DA [REDACTED]

Residential - Single Dwelling - Construction of two two-storey dwellings, each over basement car parking

FW: [REDACTED]

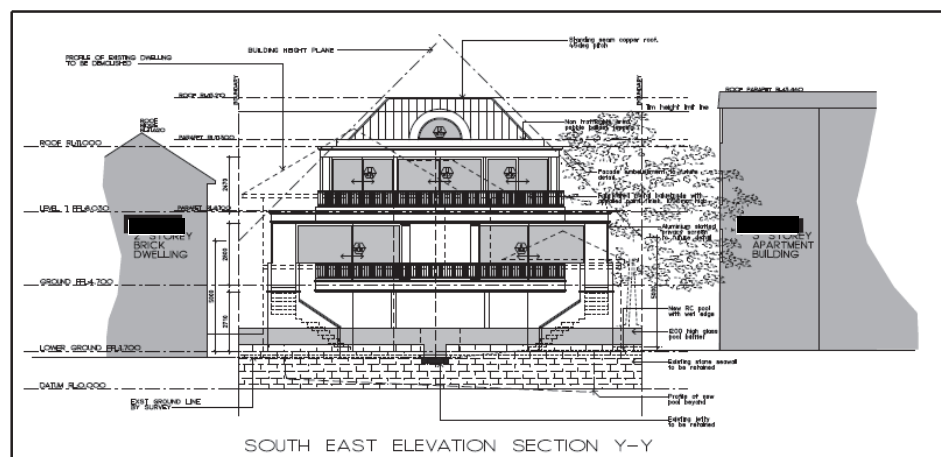
- Vehicular access and parking

Comment: The garage has been amended to provide a setback of 5-7m from the street and 2.2m from the side boundary. This results in a driveway width of 4m and introduces landscaping within the front setback of the site.

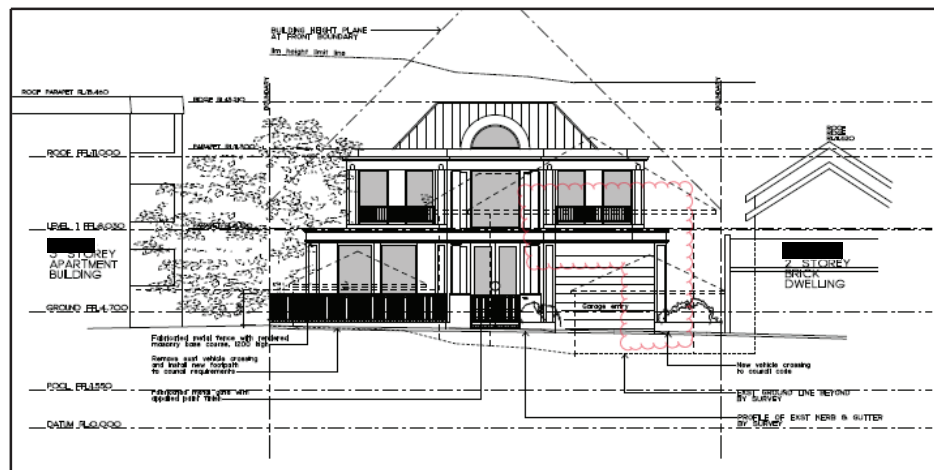
Strictly speaking the solar access control does not apply to the two rumpus room windows as they are not north facing and maintaining three hours of solar access is not reasonable due to the orientation of the site.

Due to the existing subdivision pattern, the retention of the existing solar access to these side facing windows and the POS areas of neighbouring properties is difficult to achieve given the proposed development will result in a development higher than the existing. The proposed development is not considered to be of a poor design as it possesses an overall height and form which is generally compliant with the CBLEP 2013 and CBDPCP 2017 controls and is directly comparable or smaller than a number of developments within this area.

The development is fully contained within the building envelope control which is generally held to control the overall massing of the development and has a rear setback that complies with the foreshore building line and the neighbouring properties. The dwelling will have side setbacks of 1.5-2.2m at the ground floor and 3.1-3.625m at the first floor which exceed the minimum. The overall height will be 7.5 to 9.2m which is well below

the 11m height limit that is permitted. Given the above, the shadow cast is unavoidable and reasonable.

Street elevation (Source: Applicant) Note: Roof form to be deleted via condition

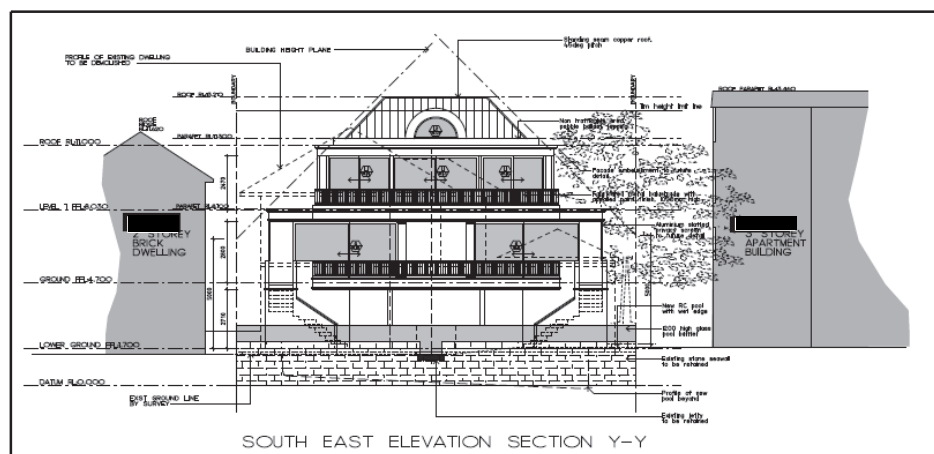
Part E3.6 of the CBD CP requires dwellings to be two storeys, however, this site benefits from an 11m building height limit under the CBLEP. The proposed dwelling will be two storeys at the street level and three storeys to the rear.

The proposal is located on a site which slopes approximately 2m from the street down to the rear of the site. The proposal utilises the slope of the land to provide a covered area at the lower level. As this is below the street level the dwelling will present as two storeys to [REDACTED]. The height of the dwelling will provide a suitable infill between the four storey residential flat building to the northeast and two storey dwelling to the southwest, as demonstrated in the elevations below.

Foreshore elevation (Source: Applicant) Note: Roof form to be deleted via condition
